Re: D0296-01 - Baltimore Waste Water Discharge Licence Application –
Reply to Notice in accordance with Regulation 18(3)(b) of the Waste
Water Discharge (Authorisation) Regulations 2007

Job Title:
BALTIMORE_WASTE_WATER
DISCHARGE_LICENCE_APPLICATION

Drawing Title:
ATTACHMENT_B.5
EXISTING_STORM_WATER
OVERFLOW_POINTS

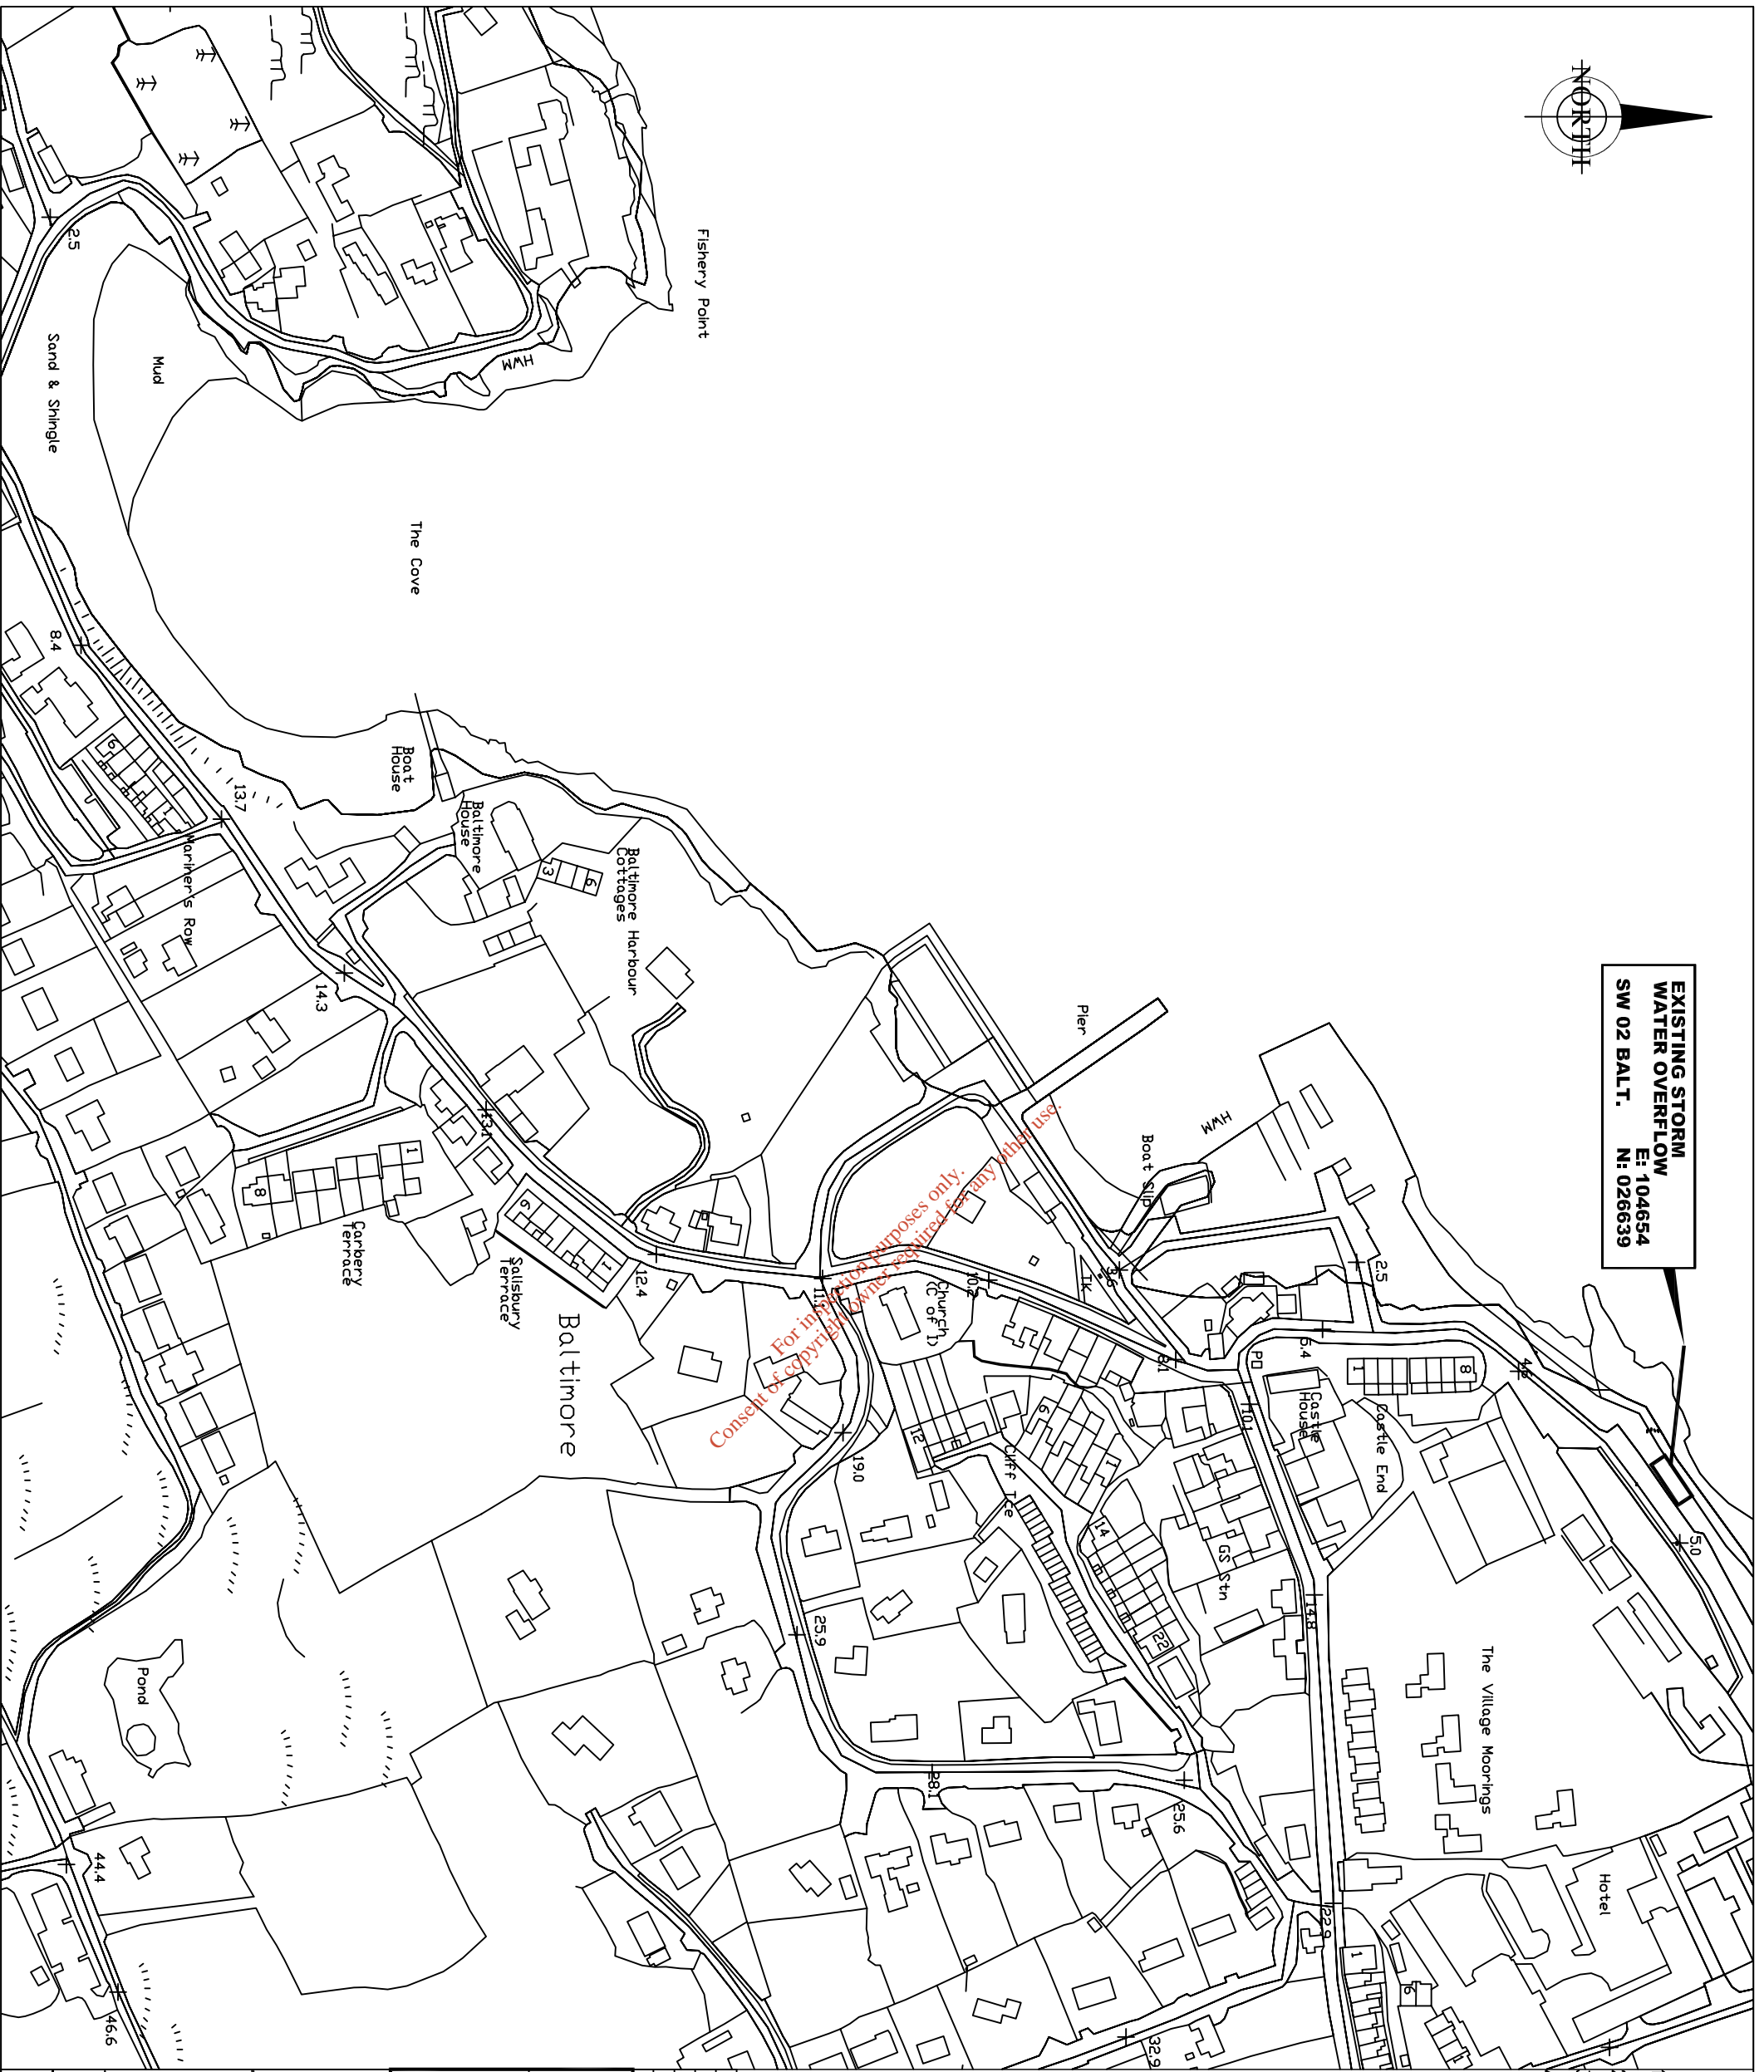
The storm water overflows attached to the pumping stations are in fact emergency overflows and are not designed as storm water overflows as stated in original Application. The two emergency overflows from the pumping stations will remain for the existing and proposed scheme.

The stormwater overflow associated with the existing septic tank will be decommissioned once the new treatment plant is built and commissioned, estimated time frame for completion June 2011.

BALT B5-01 Rev A - Existing Storm Water Overflow

No.	Date	Rev.	Description
A	06/09	OB	REGULATION_18(3)(B)_RESPONSE
